Plan Change Request

Site Address/ Parcel #: 325 Rodd Road NW Permit #: PRCCP20240215
Owner: Puyallup Training Property, LLC Email: cmcgeever@trammellcrow.com
Design Engineer: Miles McEathorn Email: mmceathorn@freelandengineering.com
Contractor: Pennon Construction Email: jacobb@pennonconstruction.com

PSE - OPERATIONAL TRAINING CENTER

ROAD & DRAINAGE PLAN & PROFILE- 12+00 - 16+00

C2.3D

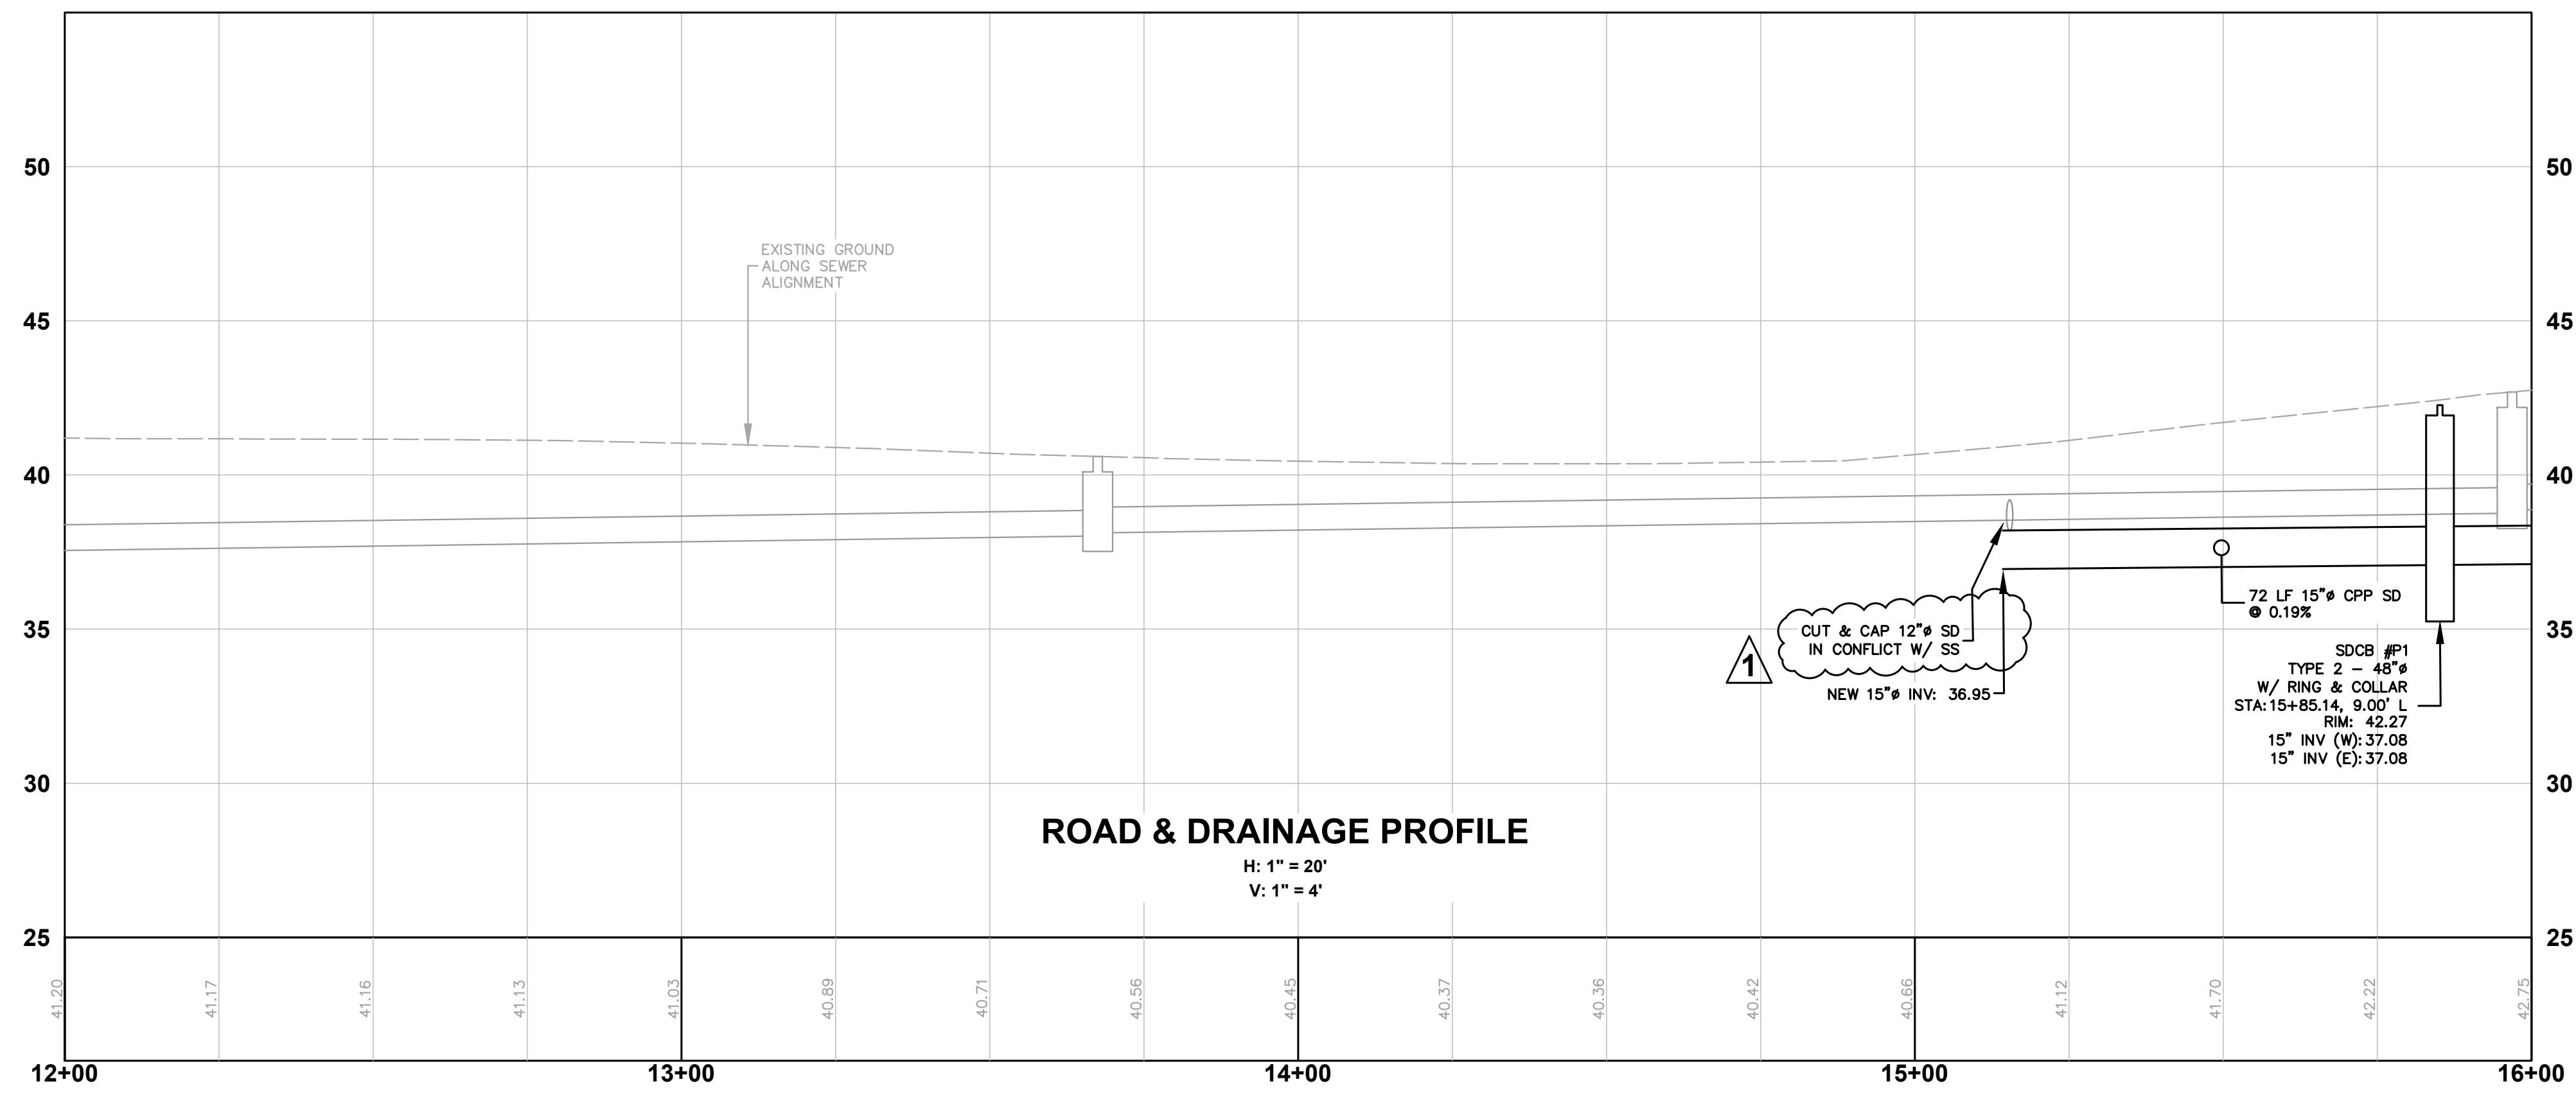
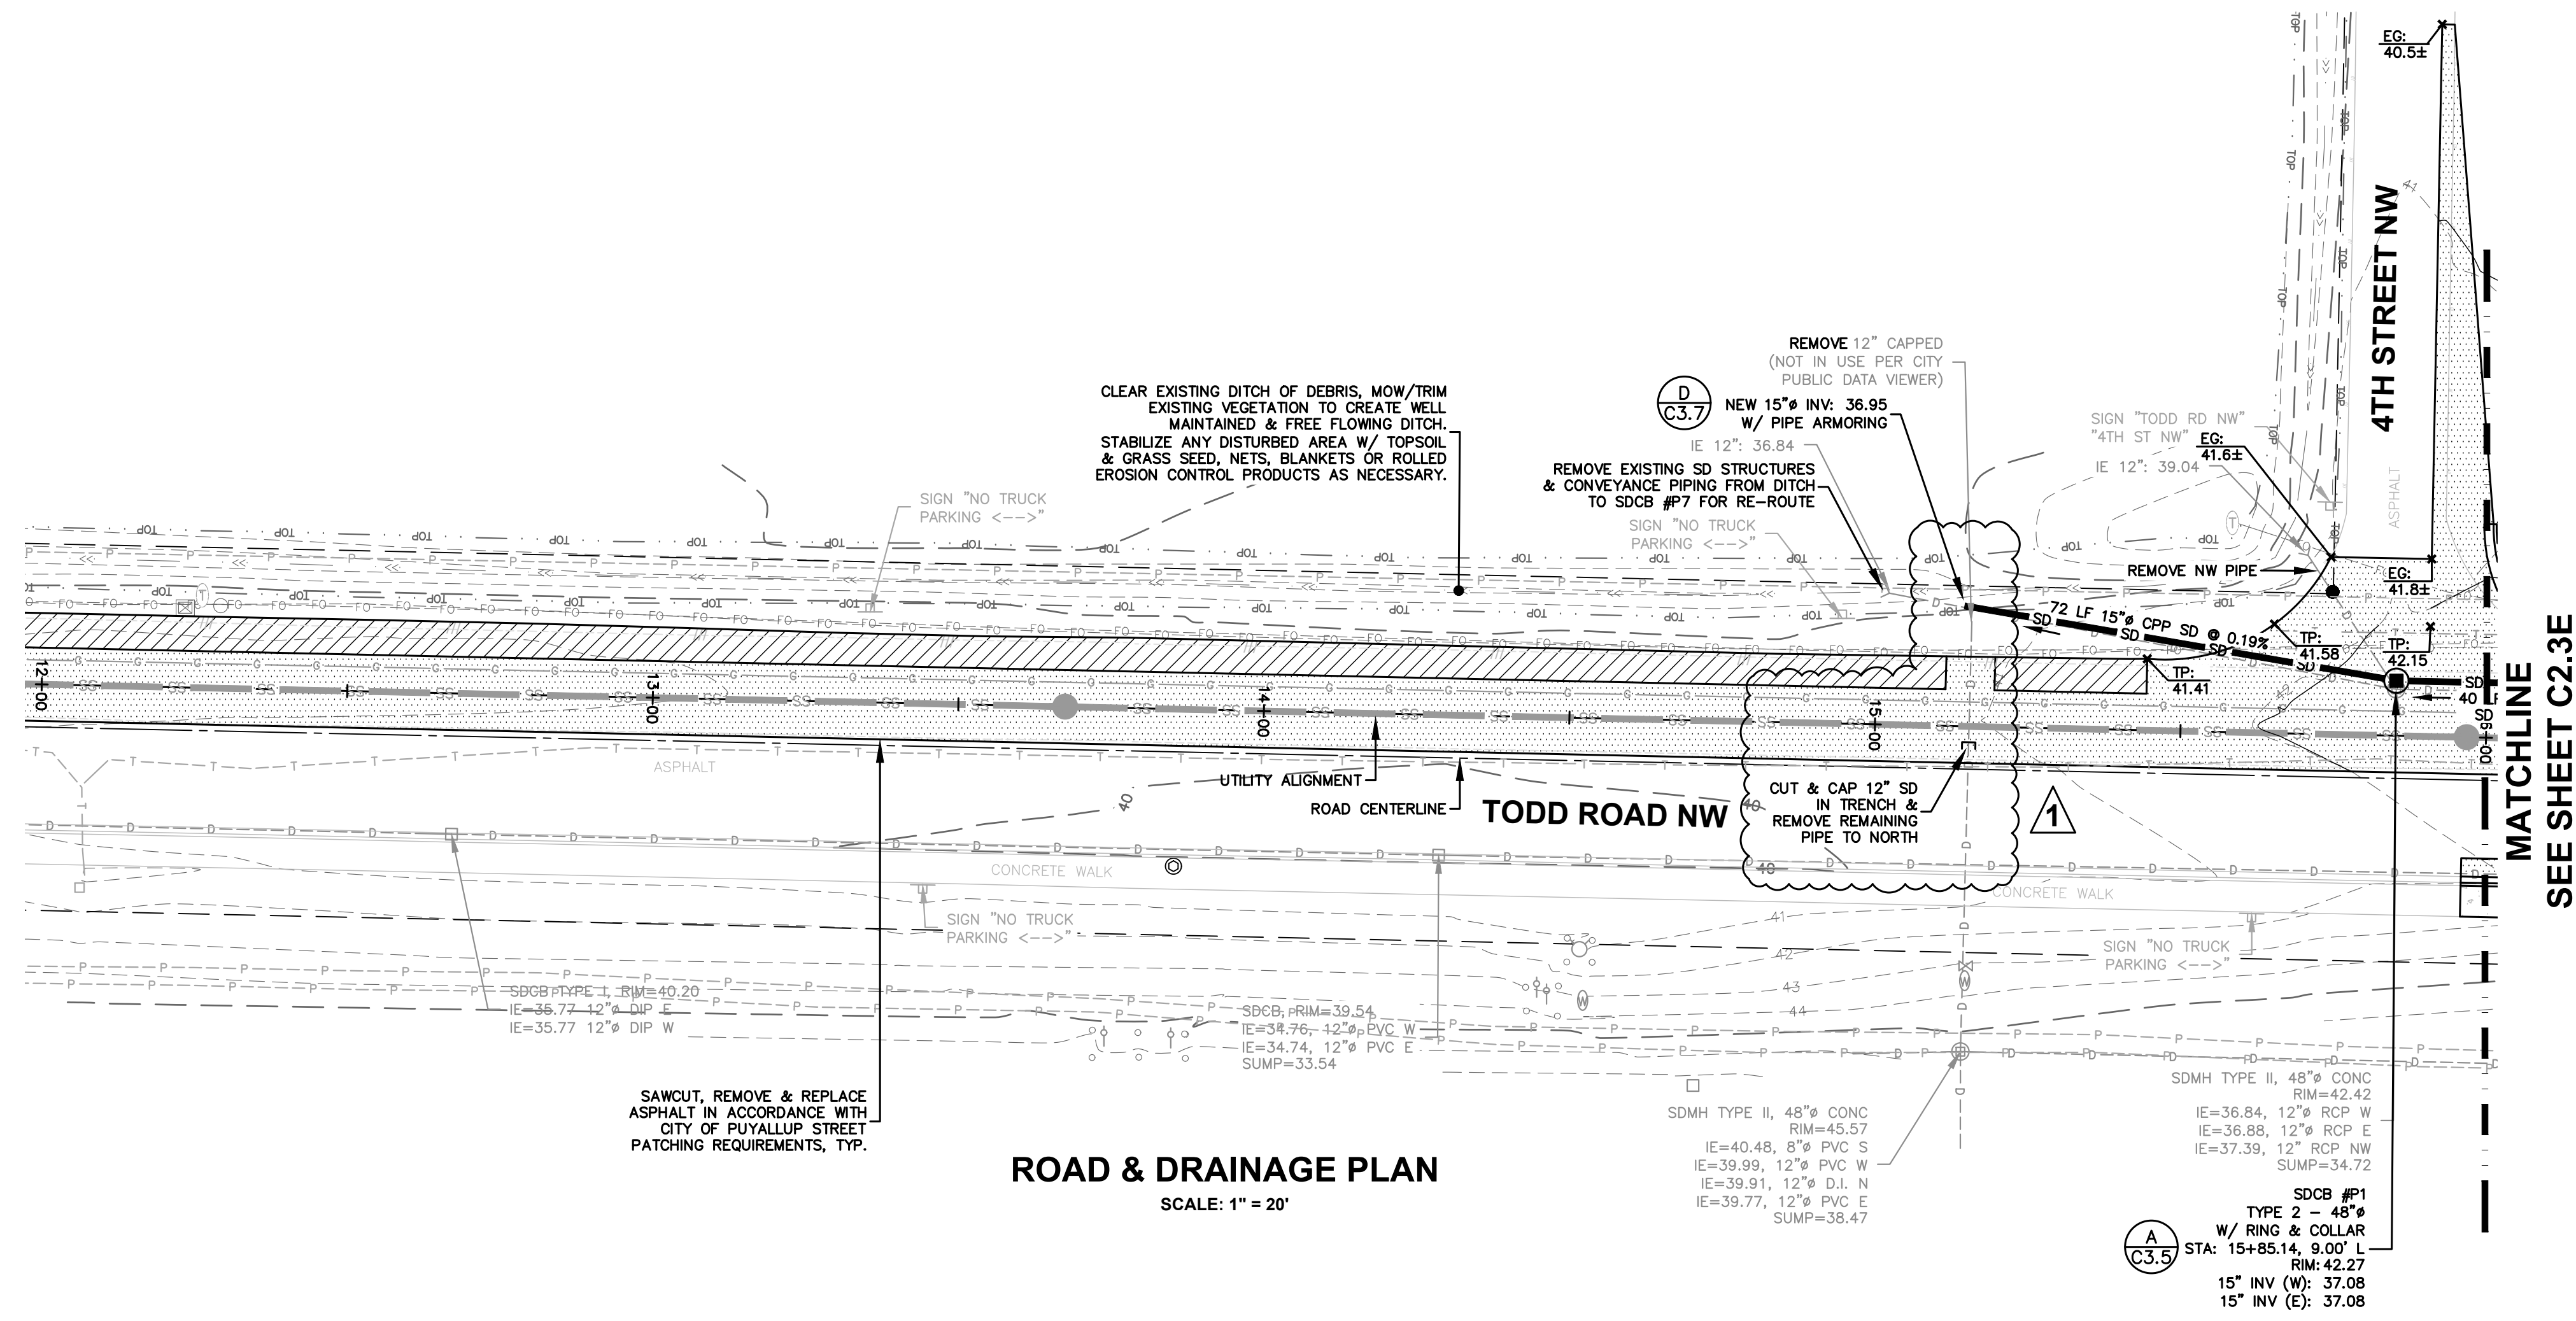
Requesting to modify existing storm drain line. City would like the existing line capped and removed. The existing storm drain line that will be modified is closed off from incoming flow with a valve and the end capped. City reports that the storm drain line has not been used since it was installed over 25 years ago.
